NOTICE OF ALTERATIONS/MODIFICATIONS

Date: April 16, 2004
Our Ref.: AVG-04-C025

Apply to: IC, TCB Issued Date: _____
Name of Appliance: Portable DVD/CD Player Model No(s): DVD-LS55
Effective Date: ☒ From First Production ☐ As much as earlier

Copper Foil covered FPC

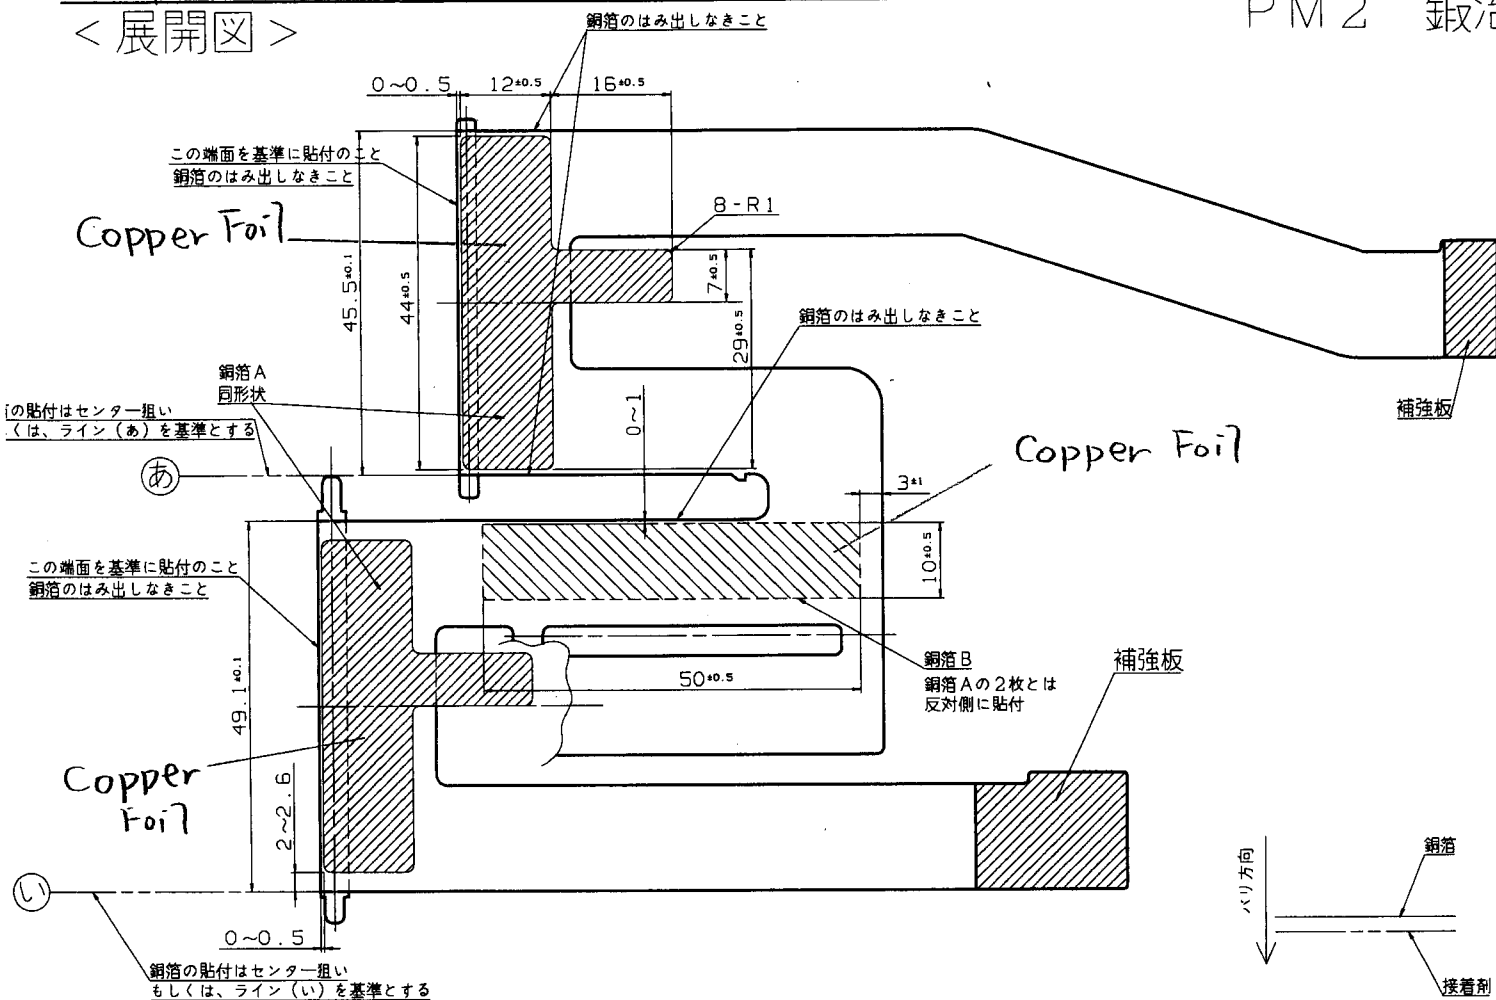
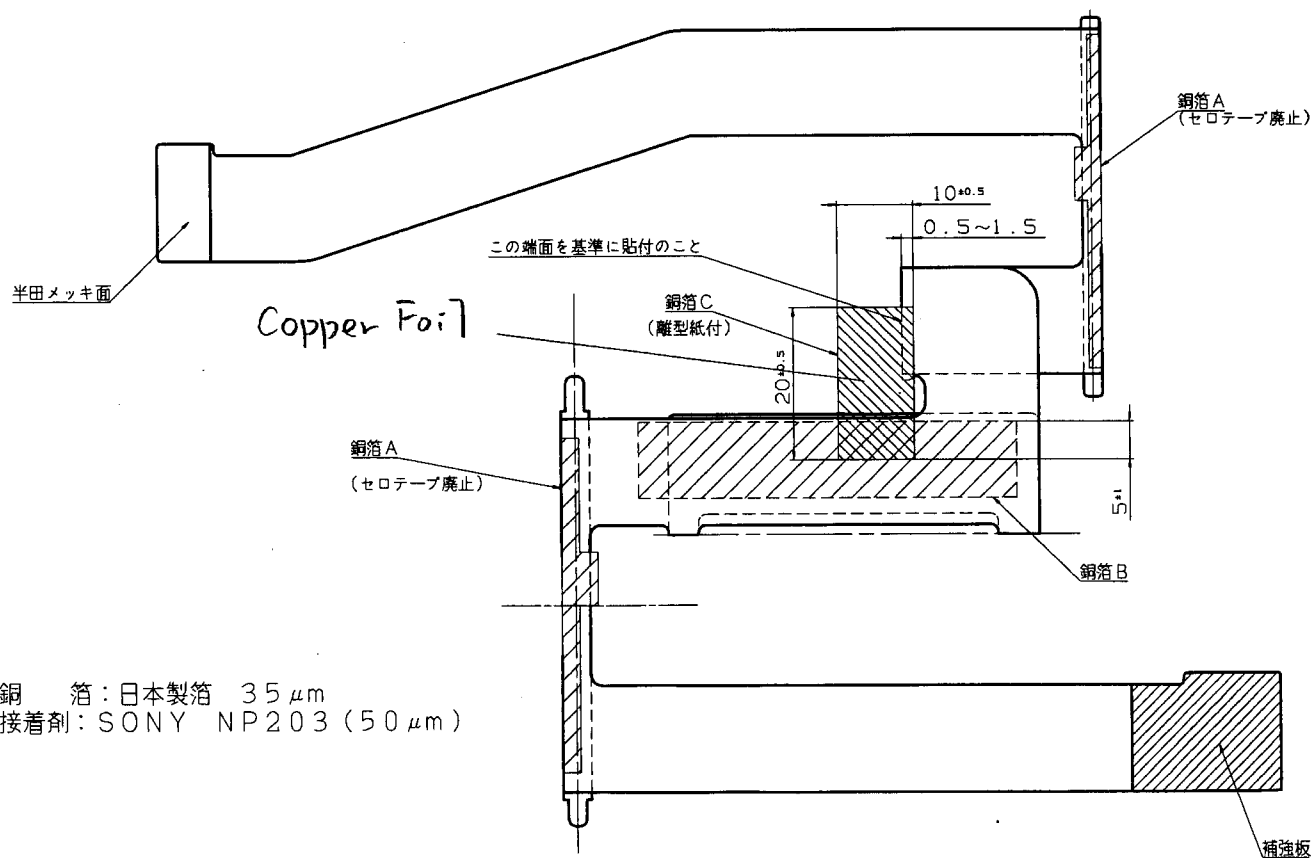
METHOD PRESENTLY EMPLOYED	PROSPECTIVE CHANGE
1. 1) None	1. Adding following components to the FM transmitter circuit . 1) Chip resistors Circuit No. : R4909 Rating : 33 Ohms 1/10 W Circuit No. : R4910, R4911 Rating : 330 Ohms 1/10 W Please refer to the revised schematic diagram we attached.
2. 1) None	2. Adding copper foils to the FPC . 1) Please refer to photos and drawing.

銅 箔：日本製箔 35 μ m
接着剤：SONY NP203 (50 μ m)
